Great North Road Solar and Biodiversity Park

Responses to Deadline 3 Submissions

Document Reference - EN010162/APP/8.29

March 2026

FIGURE 1

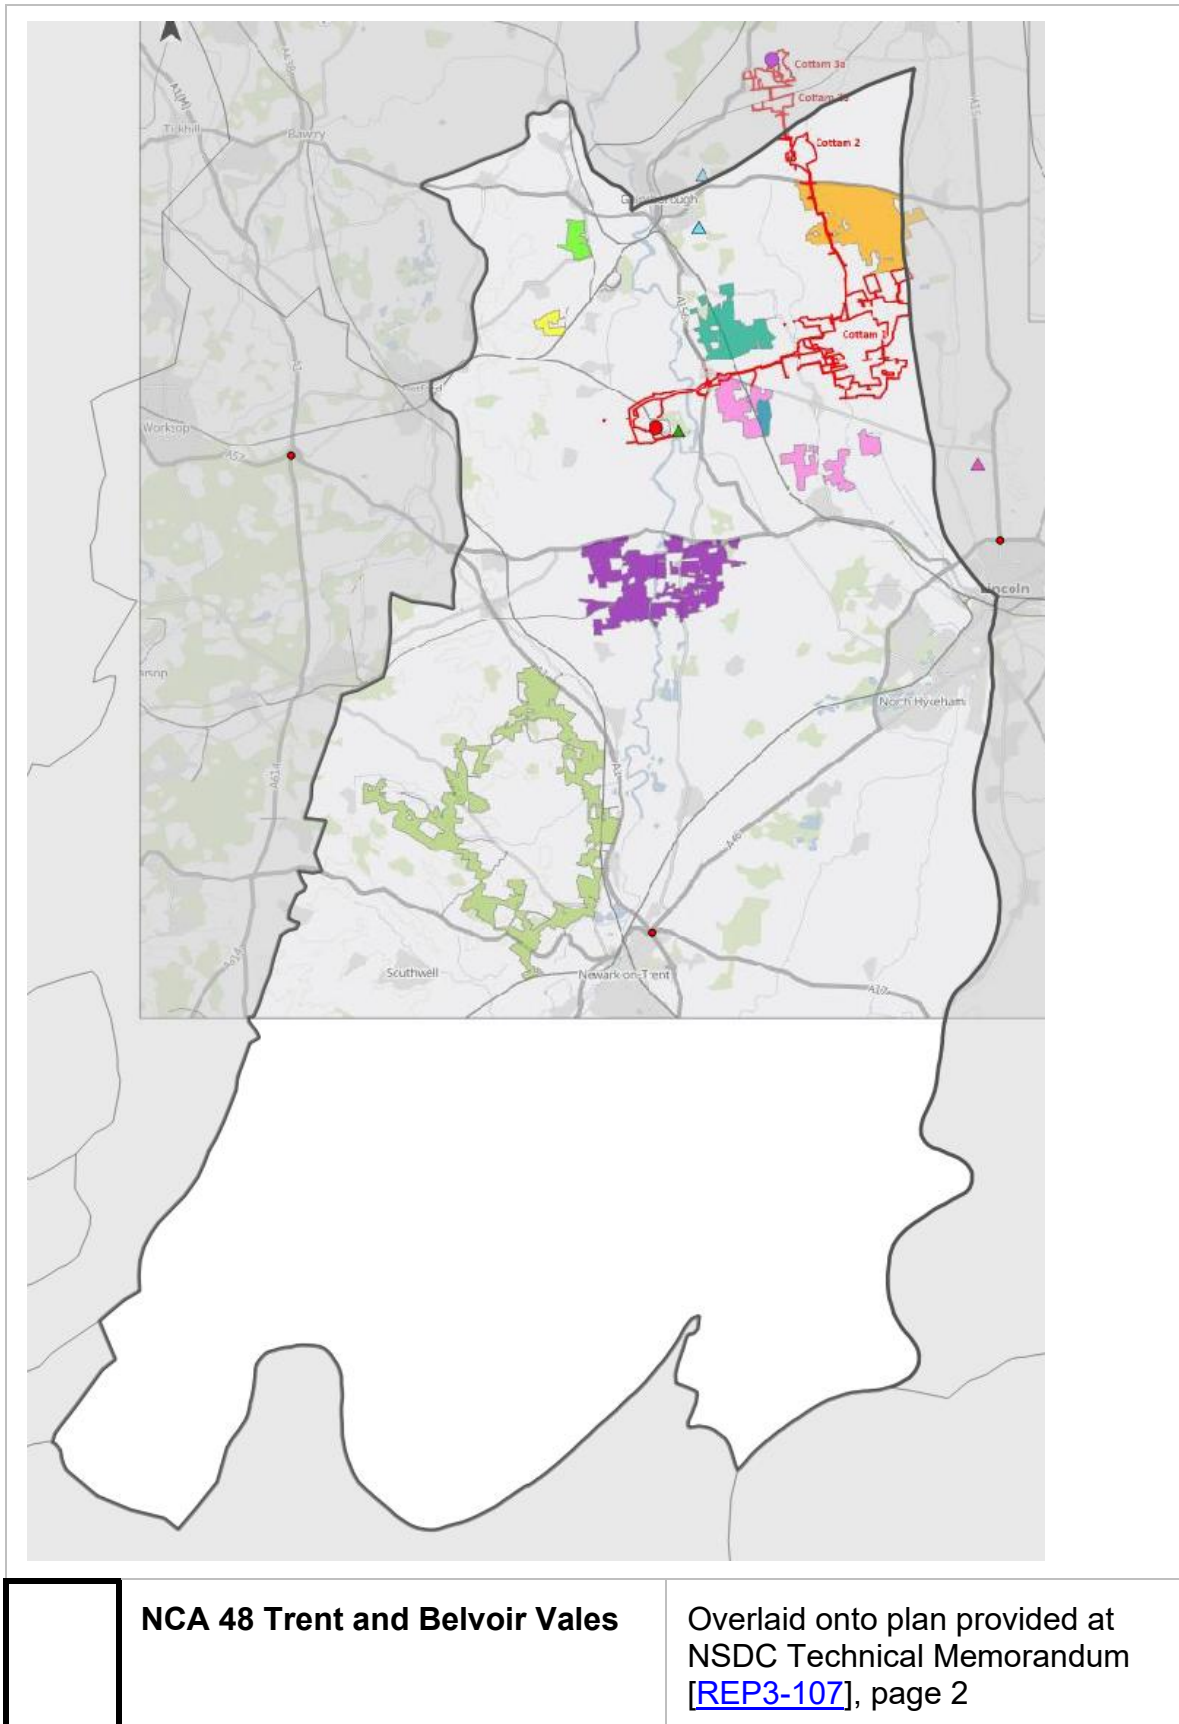
Section 3	<p><i>“Sequential effects would be experienced along multiple public routes in the wider landscape...When combined with road corridors such as the A1133 and A156, and associated lanes...”</i></p>	<p>The A1133 and A156 connect Newark on Trent and Gainsborough to the east of the Trent; 3.3km from the Proposed Development at the closest point. The Proposed Development is not likely to be visible from this route and would give rise to Negligible impacts on users of this route.</p> <p>See also the response to NSDC ISH3 Post-Hearing Submissions [REP3-106] Paragraph 7 above.</p>

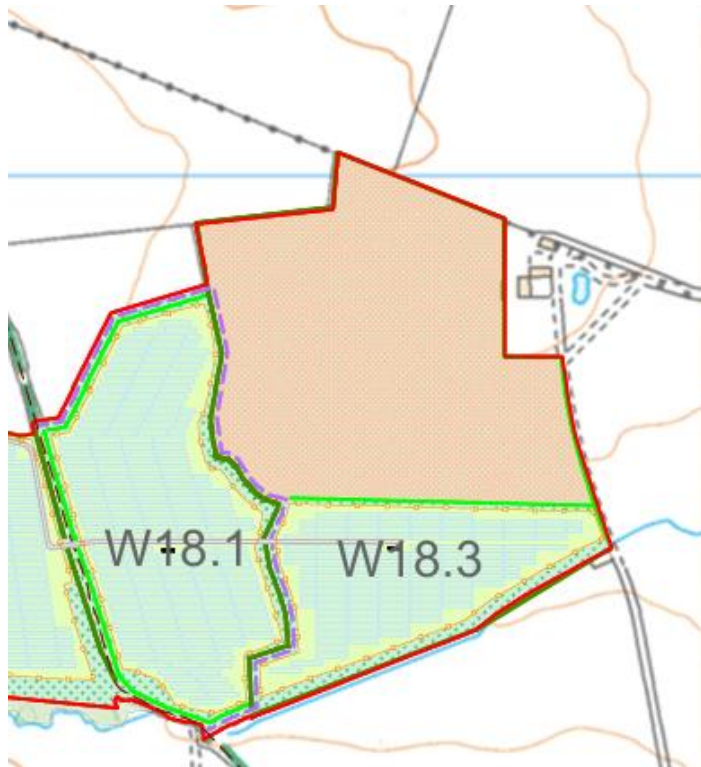
- 9.1.6 The Interested Party expressed concerns regarding the RVAA’s baseline, which states that “The Residential Visual Amenity Assessment (“RVAA”) for CLF is materially undermined by a baseline error. The Applicant’s documentation depicts an “existing hedgerow” on the southern boundary of CLF, but no such hedgerow exists; the boundary is open agricultural land, as verifiable on-site and supported by aerial imagery in the Hutton + Rostron report.”¹³

- 9.1.9 The Interested Party then further expressed concerns regarding the visual impact on CLF and openness, and stated that the proposed hedgerow “is designed without safeguarded working strip between the planting line and the residential boundary”¹⁵. As shown by the extract provided below from sheet 3 of the **Landscape Masterplan** [EN010162/APP/2.11] [APP-030], there is a retained arable field (shown in a tan colour) between the property boundary (red-line to the northeast) and the proposed hedge (bright green line north of W18.3). Given the distance beyond the property boundary (more than 150m) the proposed planting would not be close enough to cause shading and would be a very limited change in terms of openness. Please also refer to the Applicant’s responses to Richard Gill in the **Responses to Relevant Representations** [EN010162/APP/8.16A] [REP2-115], at page 214.
